Docket Number:	97-AFC-01C
Project Title:	High Desert Power Plant (COMPLIANCE)
TN #:	202996
Document Title:	Petition for Staff Approved Modification
Description:	N/A
Filer:	Joe Douglas
Organization:	High Desert Power Trust
Submitter Role:	Applicant
Submission Date:	8/28/2014 9:05:53 AM
Docketed Date:	8/28/2014

RE: High Desert Power Project (97-AFC-1C) Petition for Staff Approved Modification

**HIGH DESERT POWER PROJECT (97-AFC-1C)
PETITION FOR STAFF APPROVED MODIFICATION**

Figure 1 – Schematic of Water Treatment Equipment

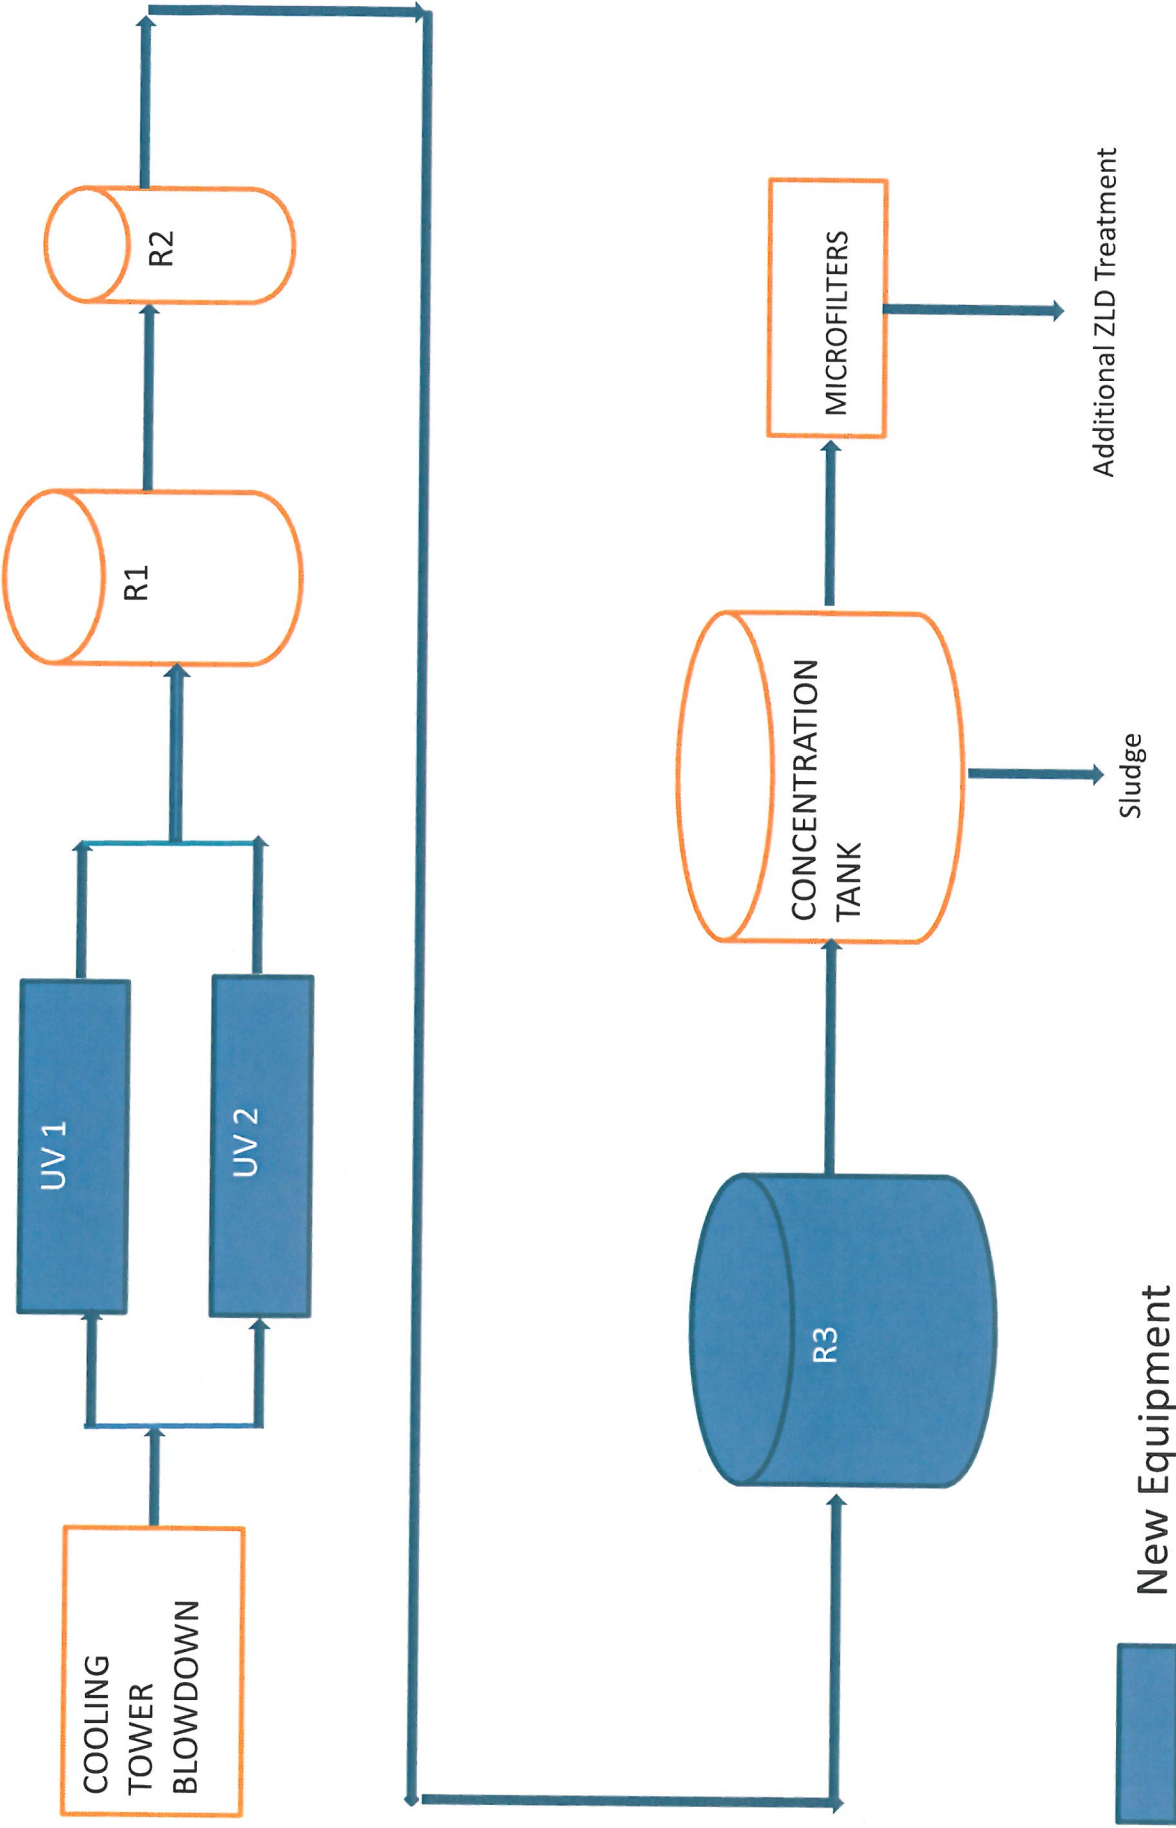
This bump out of the existing building will shelter the third, 20,000-gallon Cold Lime Softening ("CLS") Reaction Tank No. 3. The new Reaction Tank No. 3 and related facilities will be piped in series after existing Reaction Tank No. 2 and before the existing Concentration Tanks. (See, Attachment A, Figure 1.) The CLS Reaction Tank No. 3 will supply additional reaction time (i.e., "contact time") to allow magnesium hydroxide to completely precipitate, improving recycled water use, and overall HDPP efficiency and reliability.

Figure 3 – Cold Lime System Layout (Detail)

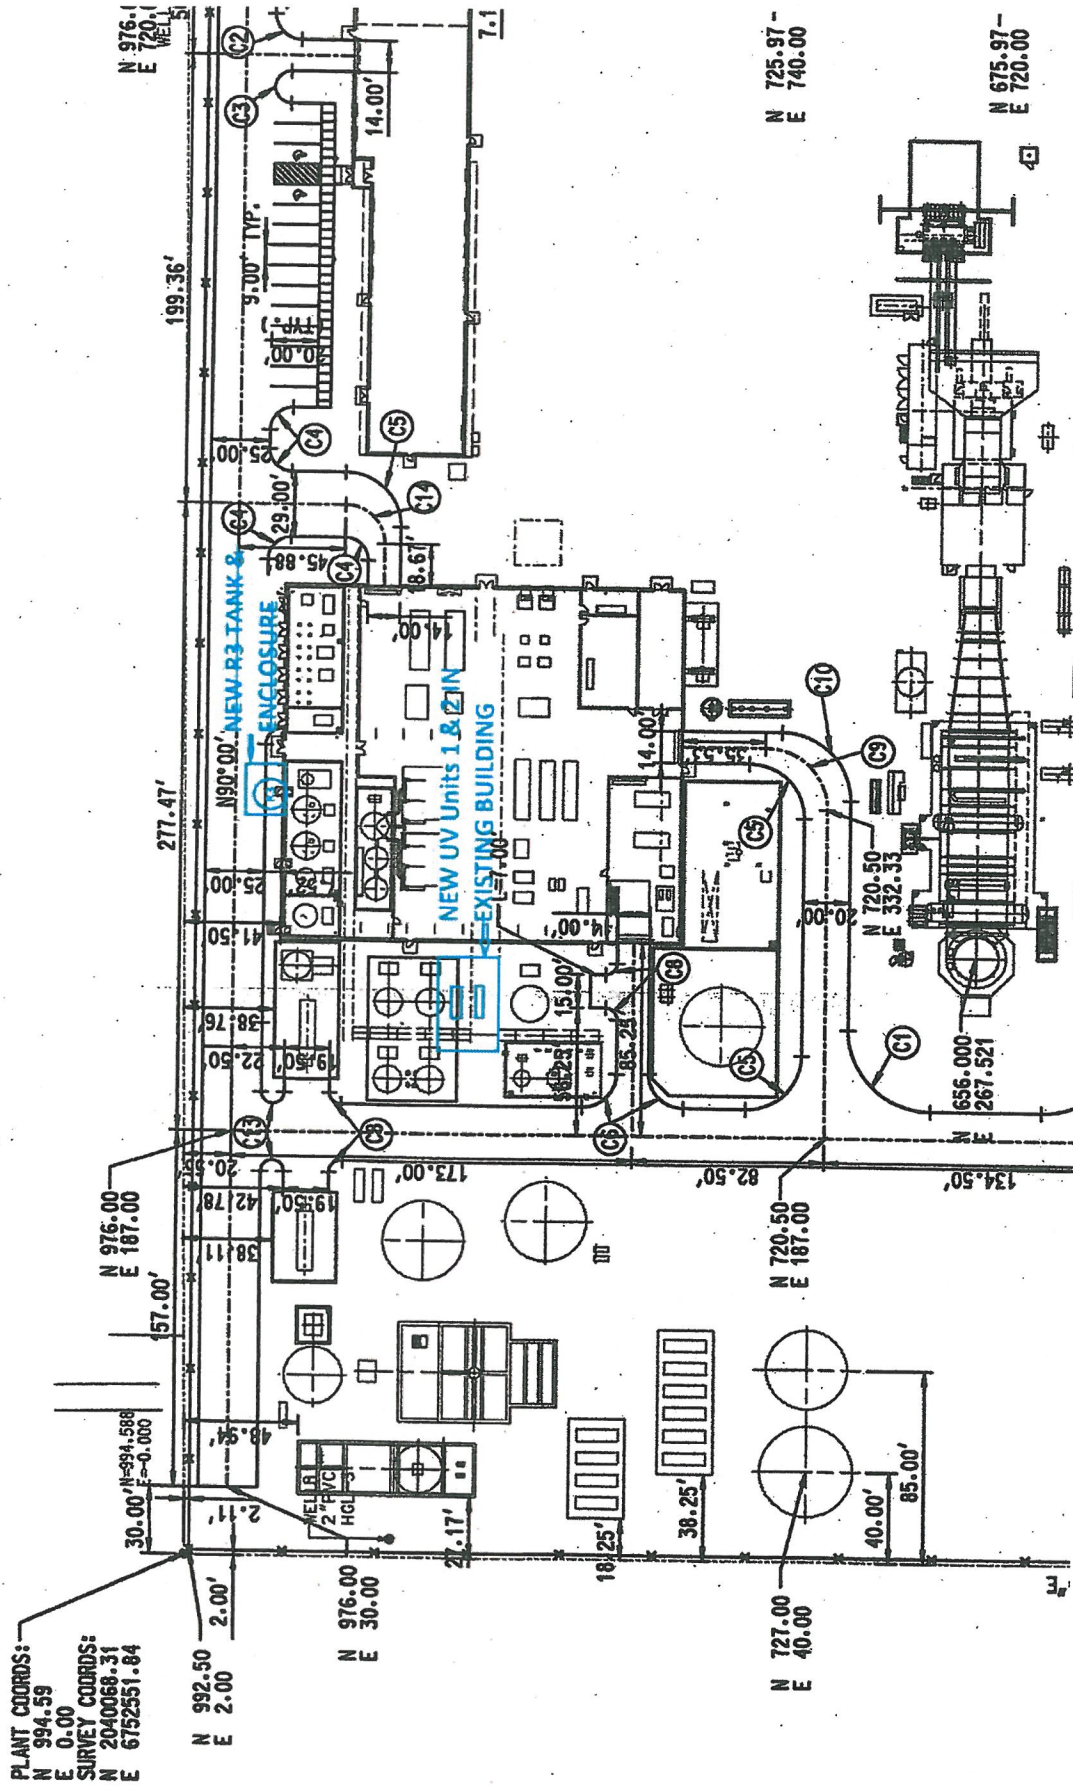
The Cold Lime System will include the minor alteration of an existing structure containing the two existing tanks already in the HDPP water treatment system. A third tank will be added to increase contact time. (See, Attachment A, Figures 2 and 3.) The minor alteration to the existing structure will shelter the third tank and will be a "bump out" of approximately 15.5 feet by 27.5 feet. The "bump out" will add only approximately 426 square feet to an existing building. The bump out will be on the existing asphalt surface surrounding the water treatment facility. (See, Attachment A, Figure 3 for a detailed view.)
